RE: Review Summary for Final PFC PA Site Visit Report at Volk Field Combat Readiness Training Center (CRTC), Wisconsin Air National Guard, Camp Douglas, Wisconsin

This letter provides a summary of the comparative review of the findings and recommendations of the *Final Preliminary Assessment Report for Perfluorinated Compounds at Volk Field Combat Readiness Training Center (CRTC), Wisconsin Air National Guard, Camp Douglas, Wisconsin* by CH2M Hill dated June 2015.

FIGURE 4
Drainage Basin 2
Wisconsin Air National Guard
Volk Field Combat Readiness Training Center

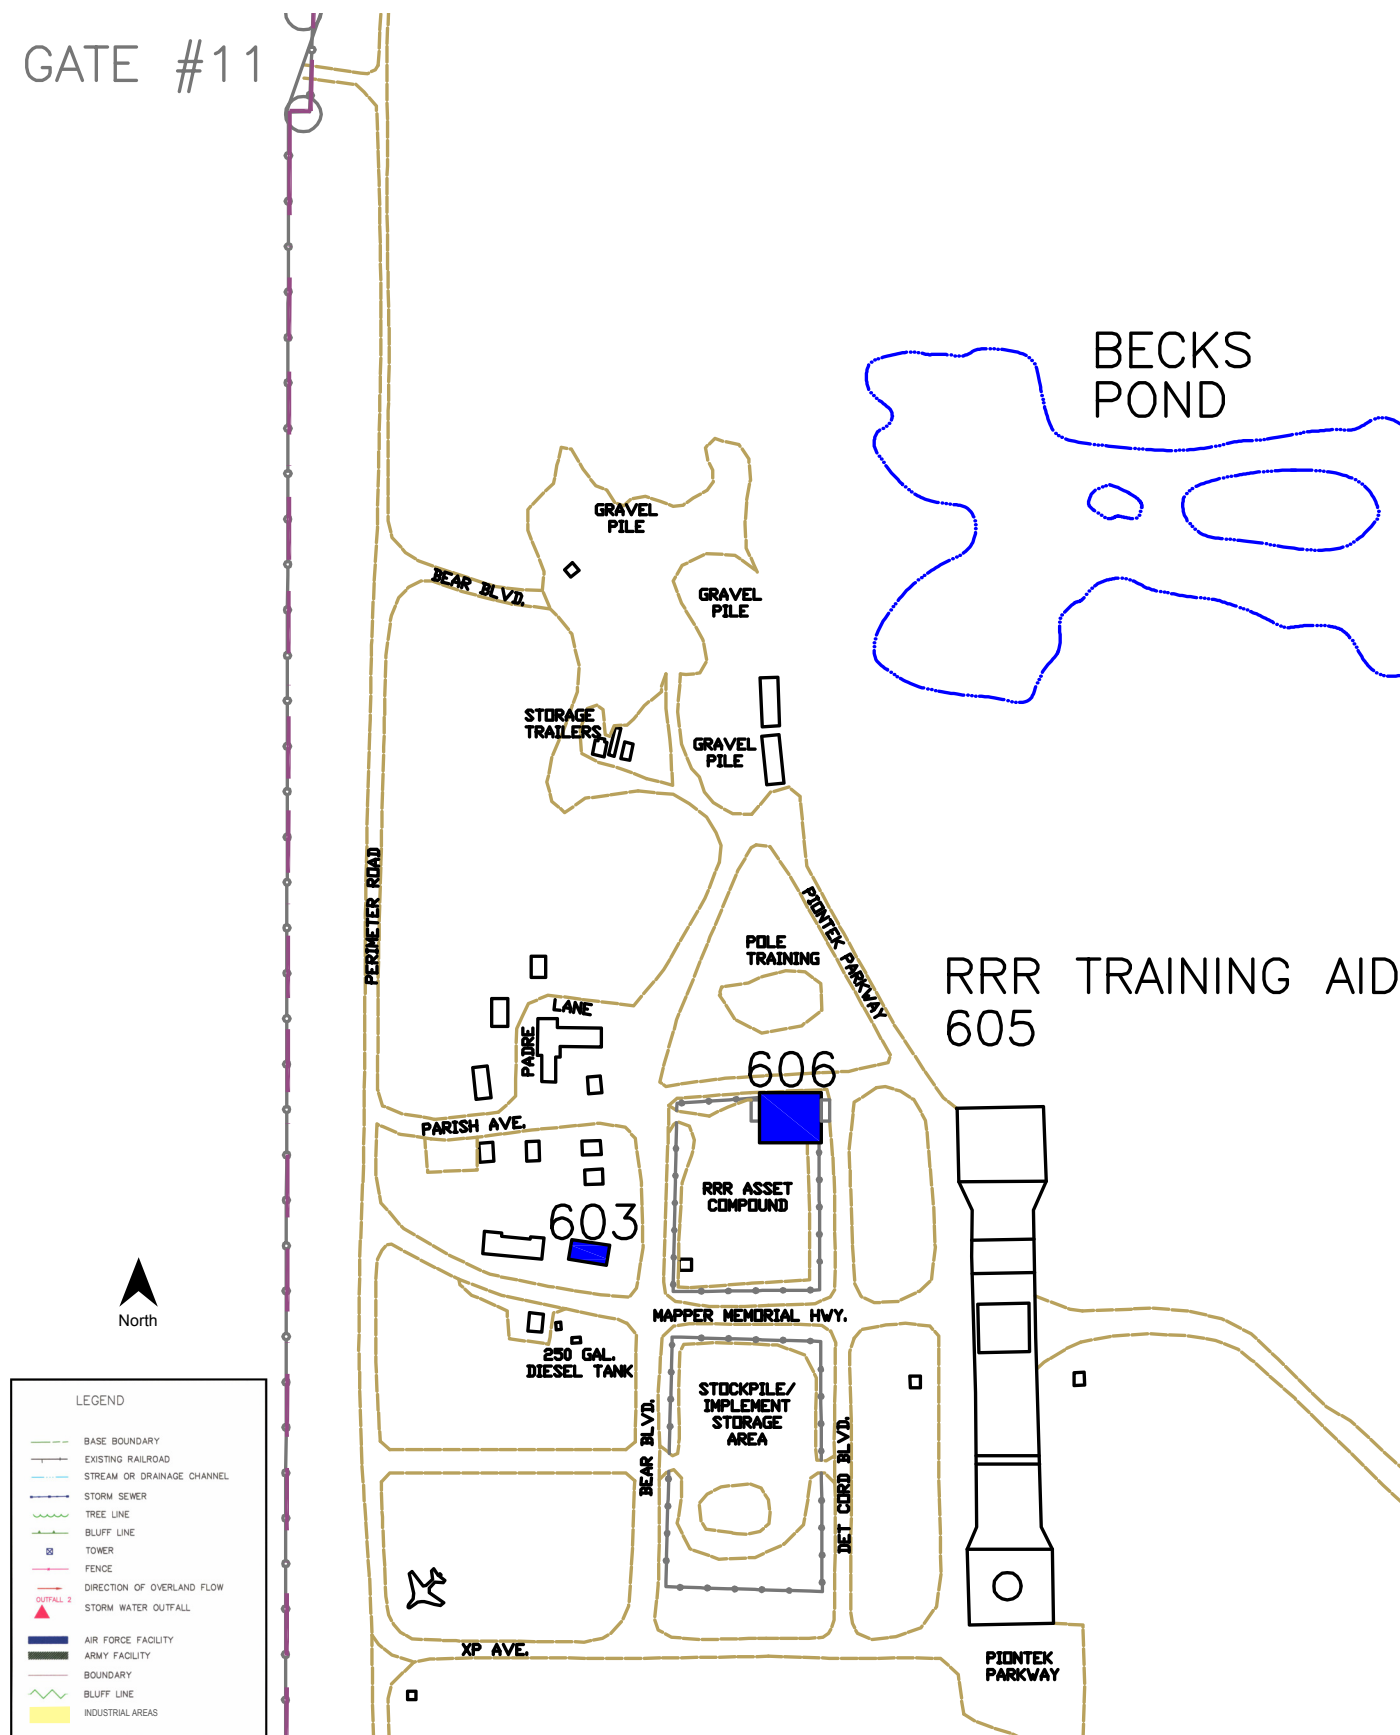
- Drainage Basin 002: This basin drains a total of 1,038 acres. Stormwater Basin 002 drains to two outfalls, Outfall #2A and Outfall #2B, located to the north and western end of the runway.

As noted in Table 1, BB&E recommends the inclusion of the on-site water production wells, the Aircraft Parking Apron and all three on-site stormwater outfalls, Stormwater Outfall #1, Stormwater Outfall #2A, and Stormwater Outfall #2B as AOCs. The location of the drainage basins and stormwater outfalls are shown on the attached figures from the *2010 Final SWPPP*.
